SLR Ref No.: 620.041534.00001-L01-Cobden RFI Response v1.0-20260610

RE: Response to Request for Further Information – Cover Letter
Planning Permit Application PA2604197
Cobden BESS – 89 Cobden-Scotts Creek Road, Cobden VIC 3266

Figure 1 Previous Plan

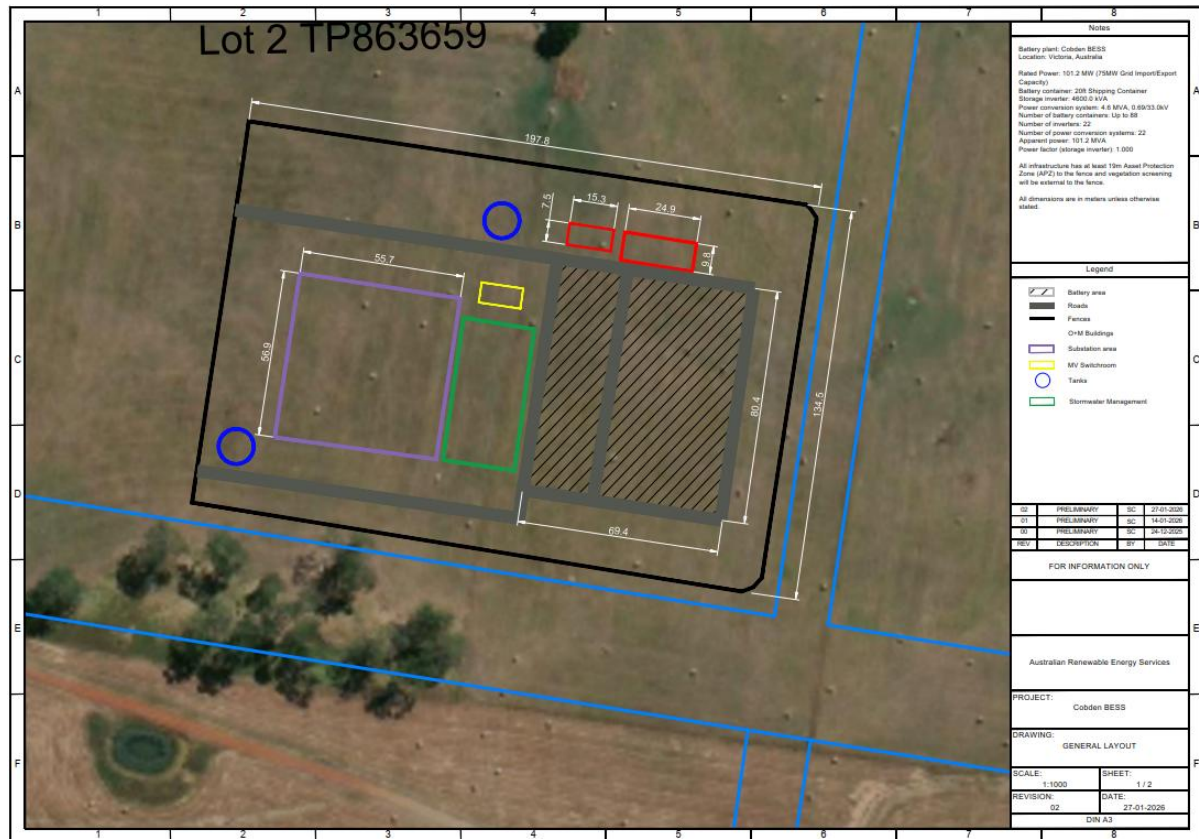
- Removal of one (1) battery container per enclosure, resulting in a total of up to 66 containers and a revised battery rack ratio of 1 inverter to 3 batteries.
- Inclusion of 5m wide landscape screening along the entire perimeter of the Project Area.
- Provision of additional internal roads, hydrant locations, and associated infrastructure reconfiguration.
- A 4m high noise wall around substation transformer.

The Development Plans, Planning Report and all supporting technical documentation have been updated to reflect these changes. Refer to Table 2 for a comparison of the previous and proposed development specifications. Refer to Figure 1 and Figure 2 for the previous and revised Plans, respectively.
